30 March 2022

Response to Peer Review of Hydrogeological Assessment and Groundwater Management Plan prepared by Dr Robert Banks

Map 03	Map
Lot 2 Gundy Rd, Scone, NSW	Site
Proposed Subdivision	Project
Groundwater Assessment Peer Review Response	Sub-Project
Charles David Pty Ltd	Client
30/03/2022	Date

Figure 1: Soil salinity mapping at 0.5 m depth (source: Figure 3-2 GHD 2020 Report).

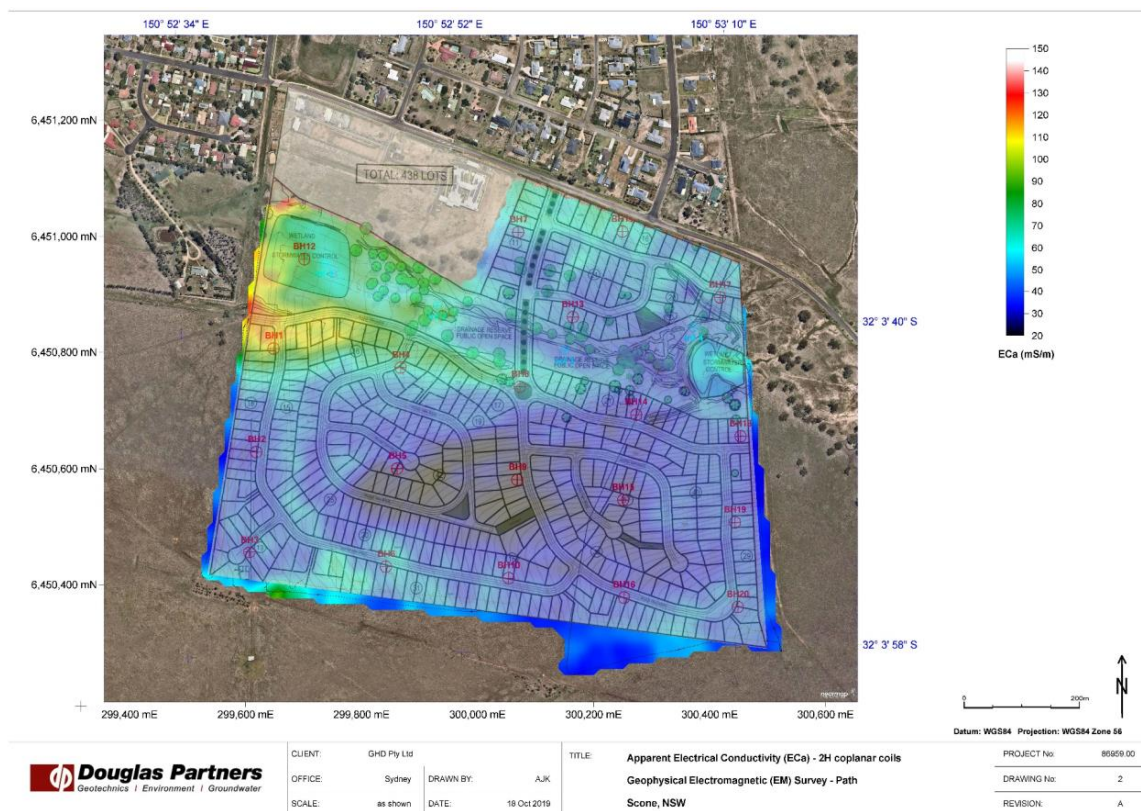
- b. The EM Survey data indicate that there is predominantly slight to moderate salinity² within site surface soils, except in the lower western portion of the site (refer to Figure 1) where moderate levels occur.

Figure 2: Soil salinity mapping at 1.5 m depth (source: Figure 3-3 GHD 2020 Report).

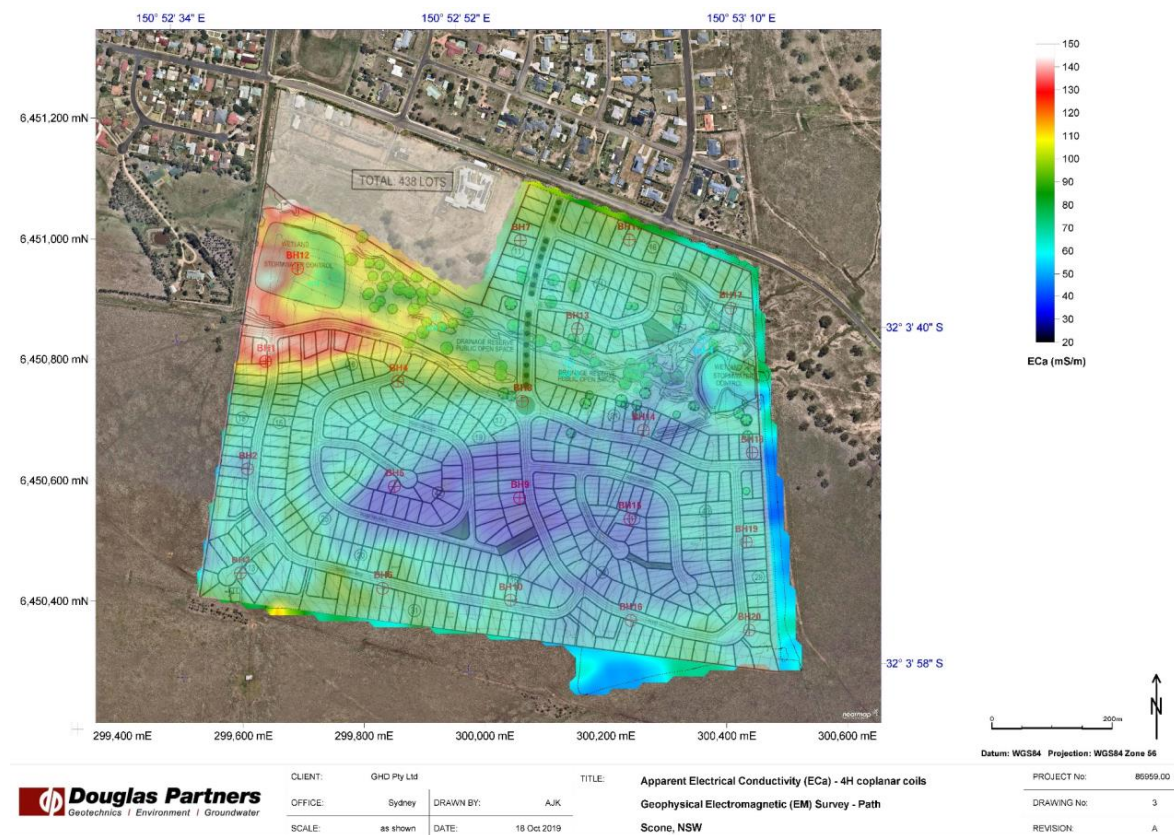
- c. The EM Survey for sub-soils (at 1.5 m depth) indicates that salt levels are higher at depth, with the highest levels again found at the lower western portion of the site (refer to Figure 2) where there is a distinct area of high salinity.

Figure 3: Other areas of known salinity (site boundary in red).

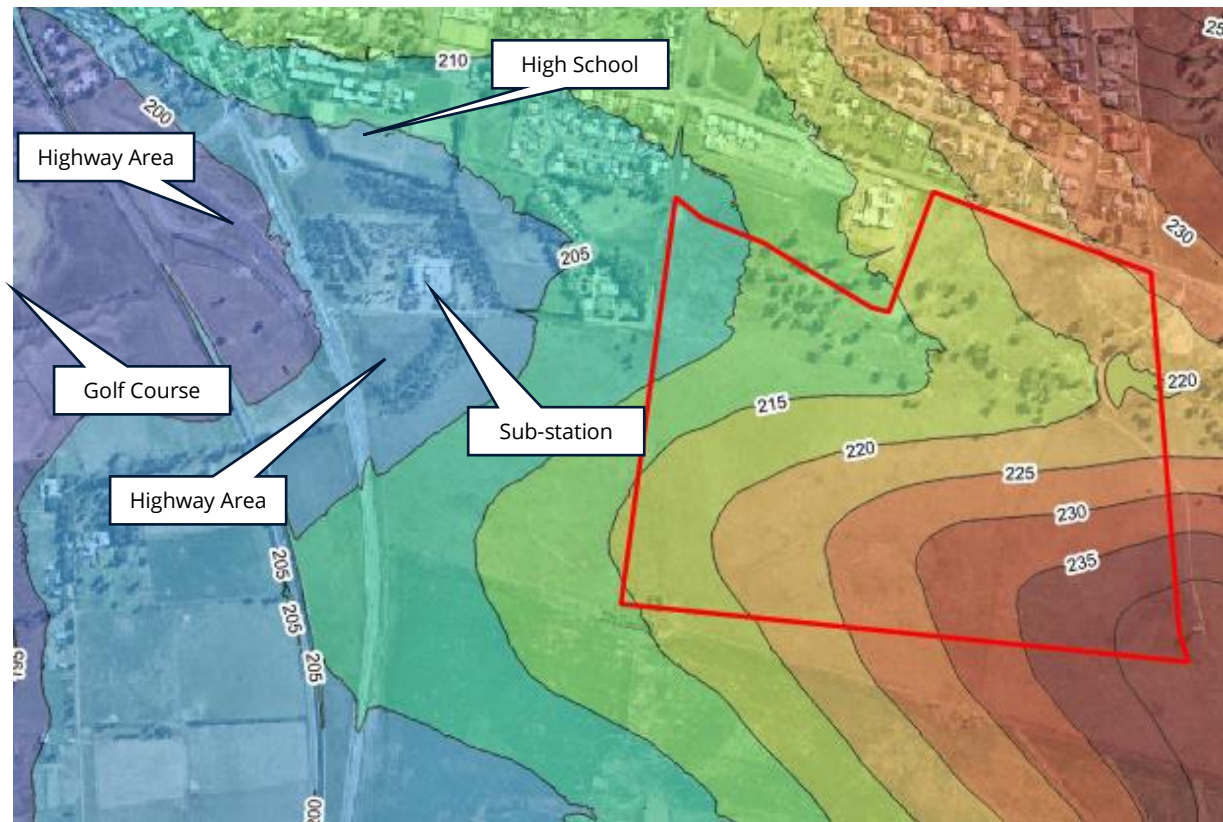
1. Existing known salinity affected areas can be found at the Scone High School, the nearby power sub-station, upslope of the New England Highway, and in the Scone Golf Course (refer to Figure 3 for approximate locations).
2. These areas are generally located below the 205 mAHD contour, in low lying areas of relatively poor drainage where there is an increased risk of groundwater, at least intermittently, coming close to the surface.
3. It is possible that the construction of the New England Highway may have contributed somewhat to local upslope salinity effects by impeding or locally slowing the flow of groundwater. However, the effect of this does not appear to have reached the site which is elevated at least 5 m higher than these salt-affected areas.

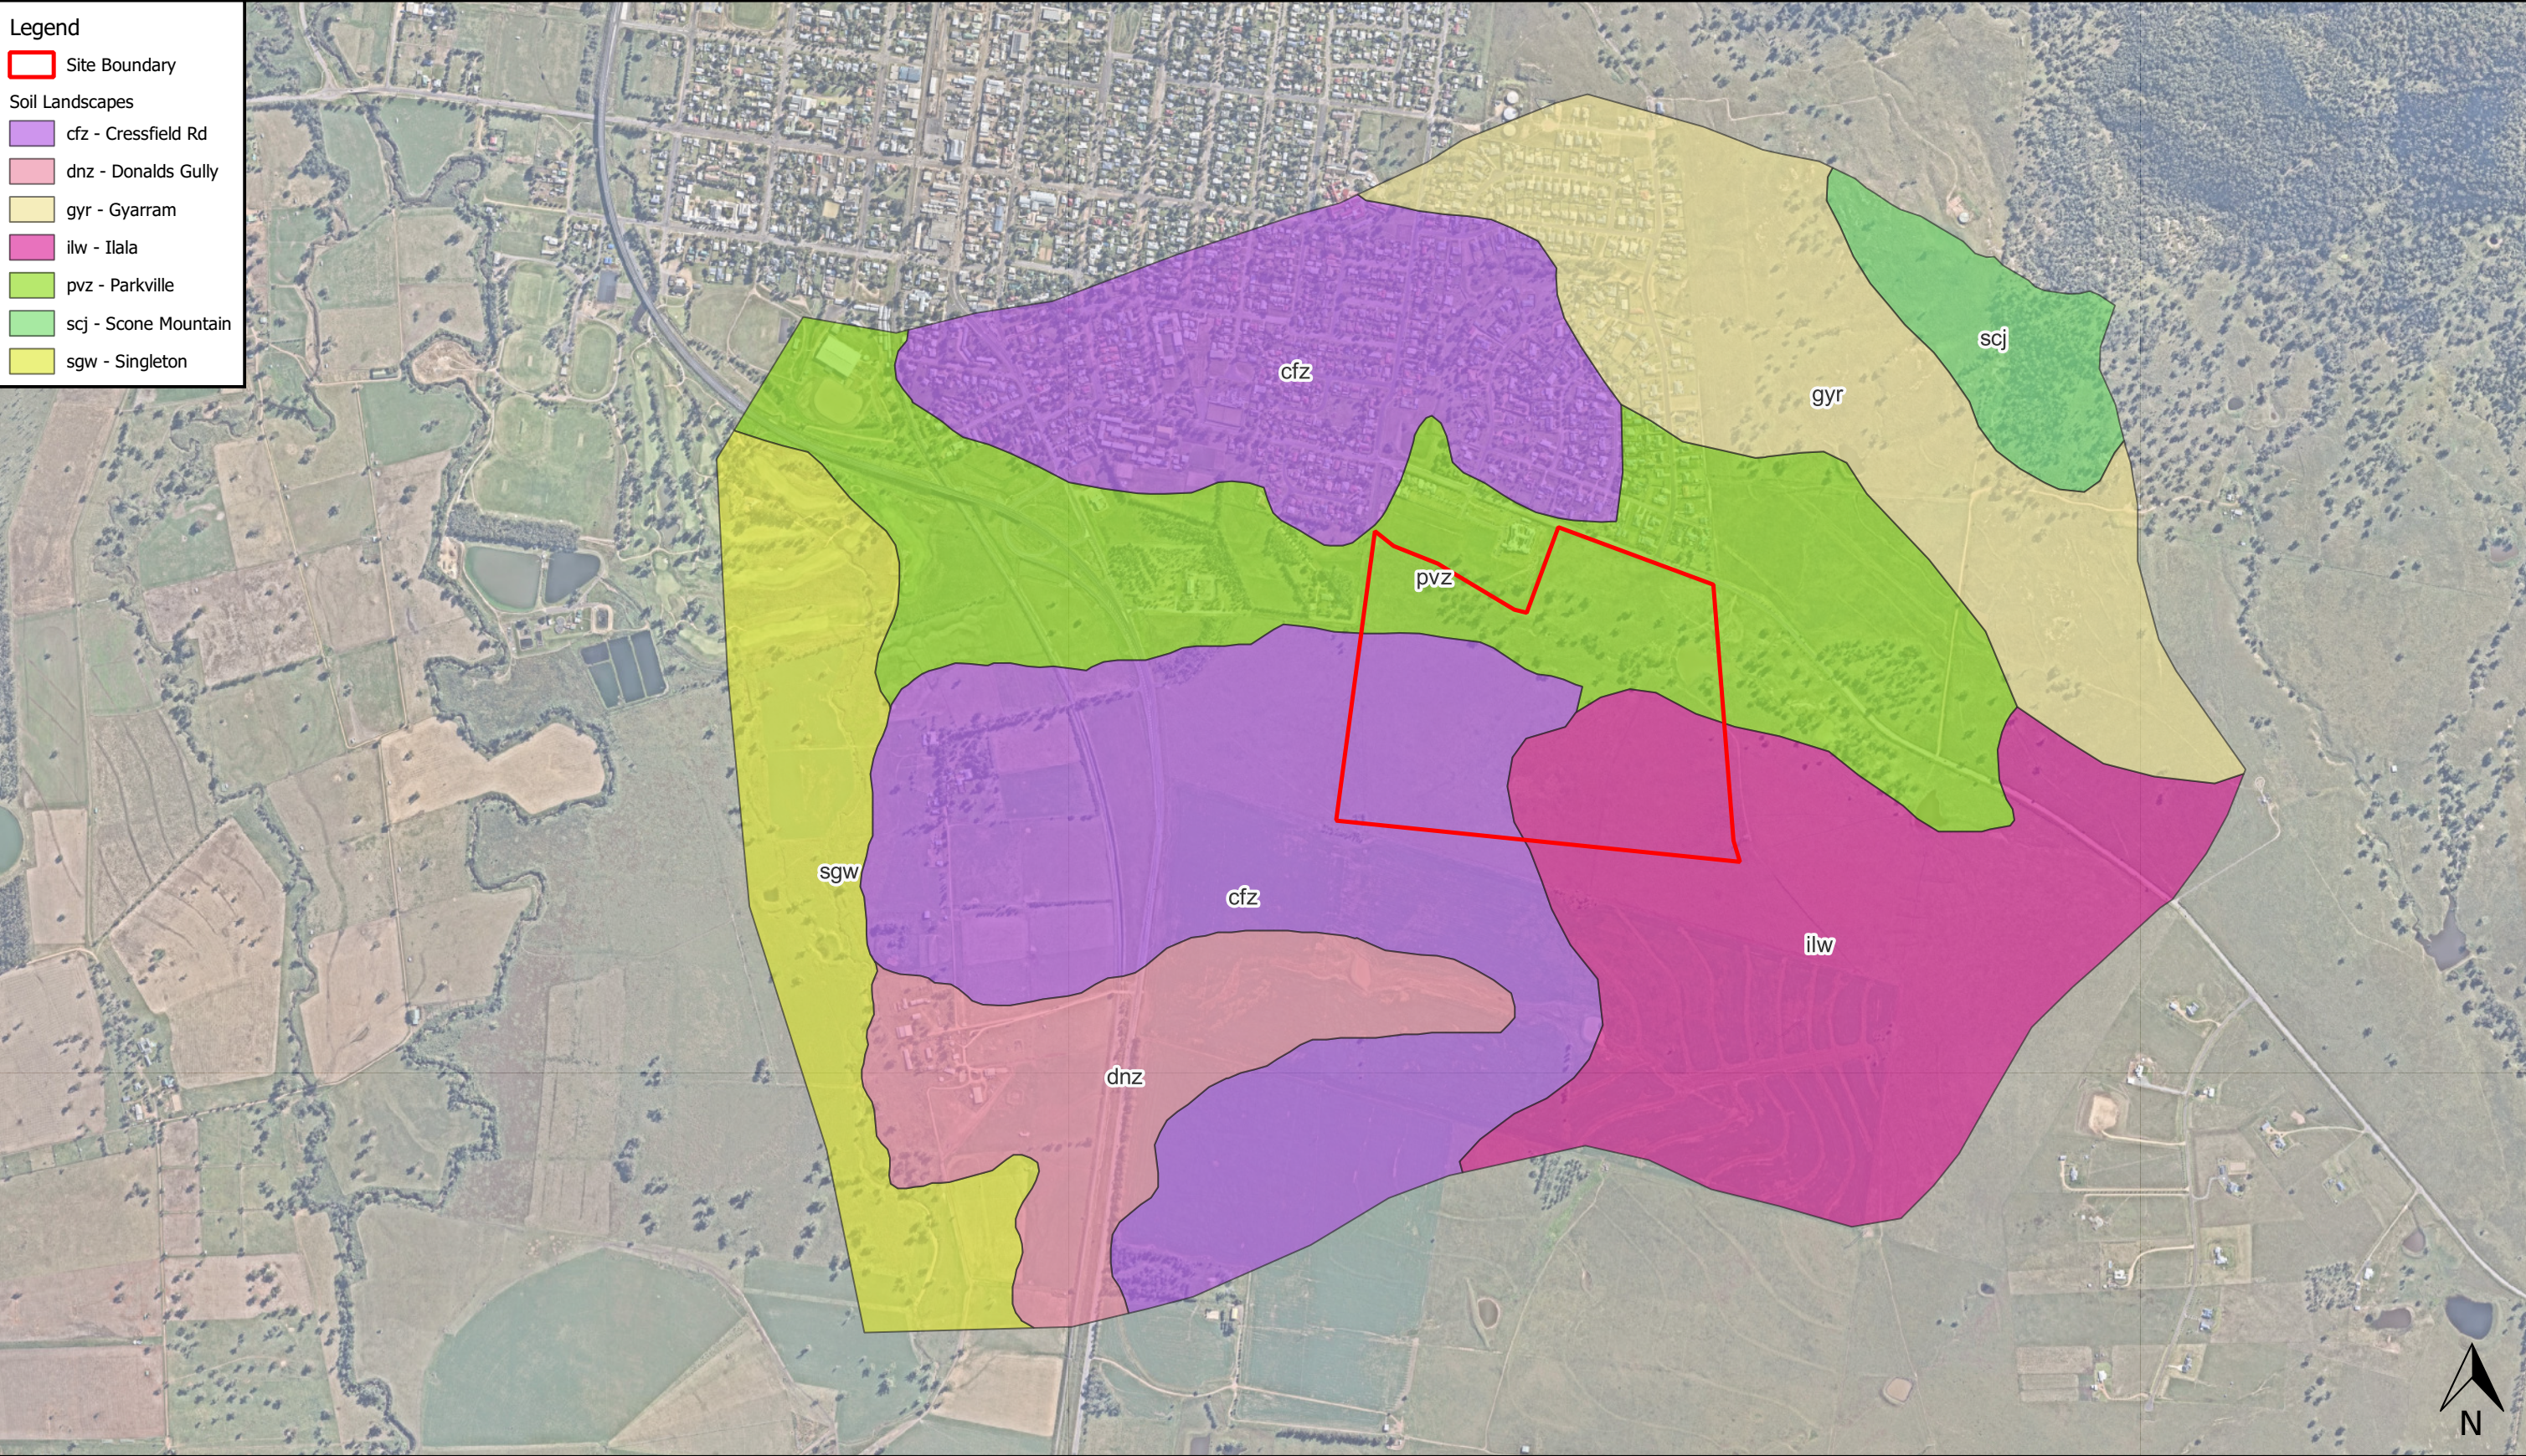
9. Update MODFLOW based on eSPADE soil data	<ul style="list-style-type: none"> Soil material properties have been updated in accordance with the latest eSPADE soil data (refer to Map 2).

Location of the soil material zones used in the modelling is provided in Map 2.

Post Development Groundwater Model Modified Recharge and Evapotranspiration Zones

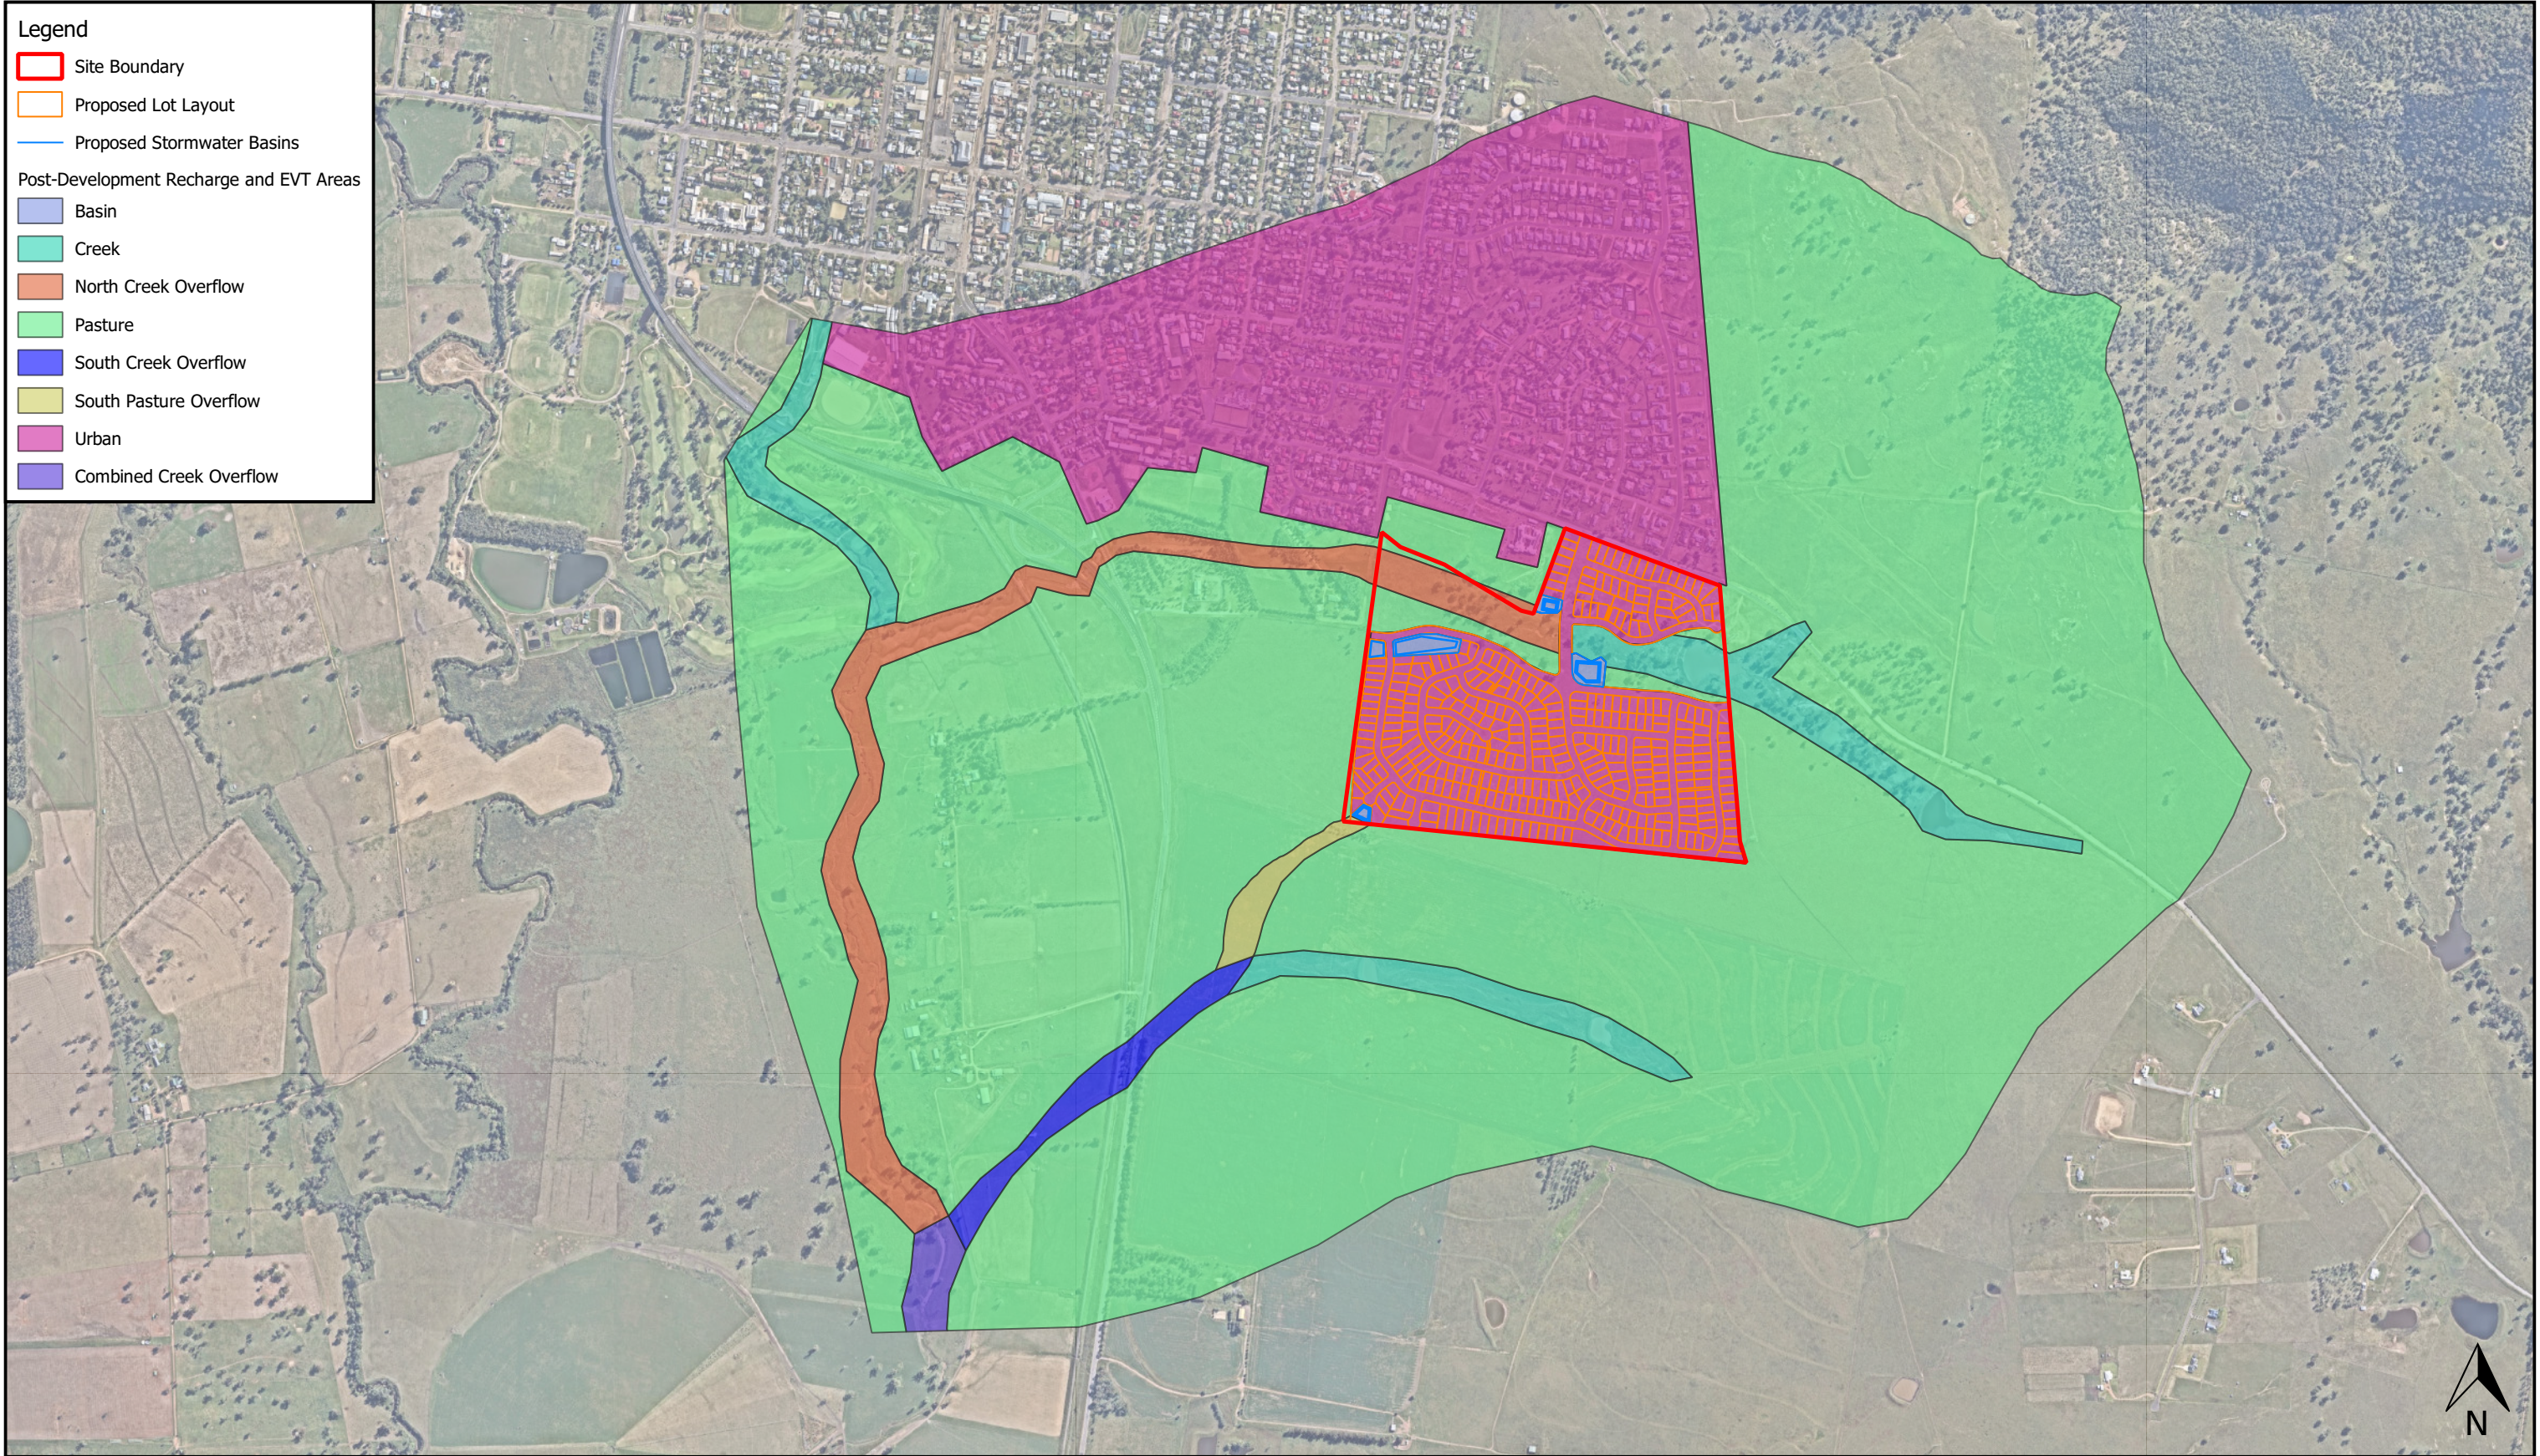
1. *Existing conditions*: Specific recharge zones were created for the two drainage lines receiving discharge from the site (refer to Map 4).
2. *Developed conditions*: Recharge was increased in the drainage line recharge zones where stormwater was discharged, by an amount proportional to the increased annualised flow volume (refer to Map 5) noting:
 - a. Annual flow volumes were evaluated using the MUSIC stormwater modelling software, which indicated that the development would lead to a net increase from around 141 to 238 ML/year in the northern drainage line, and 52 to 84 ML/year in the southern drainage line.
 - b. The effects of these increases were included at and downstream of points where site stormwater would be discharged, over an area that overland flow could reasonably be anticipated to impact.
